DATE: 02.08.13
TO: ProTrack
FROM: Tara S. Murphy, ASLA/RLA/LEED AP
Transportation Planning

■ **BULLZEYE SHOOTING SPORTS [2nd Review]**

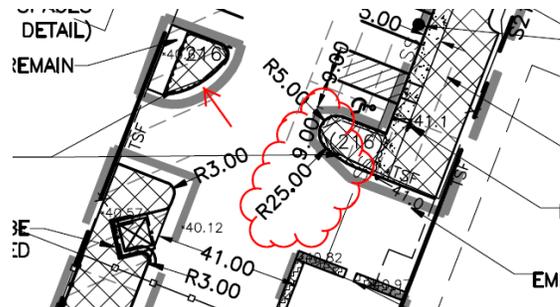
1. Provide sidewalk detail SD 8-15 on the plan. 2nd Review Update: Ensure this detail is on the plans for signature. The detail sheet as referenced in the written response letter did not accompany the submittal. (Thank you for the letter.)
2. Dimension the radius below.

3. The minimum radius is 25' for any portion of a parking lot adjacent to a travel way (i.e. islands at the end of a parking bay) for parking that is open to the public. If the travel way will not be used for emergency service vehicles or truck traffic, you may request a tighter radius, the minimum is 15'. This request must be made in writing (an email message is acceptable). 2nd Review Update: Please see radius clouded in illustration above. This is not correctly drawn. Please either provide an exhibit that indicates the turning movements of the waste management truck are adequate or construct this radius along the travel way.
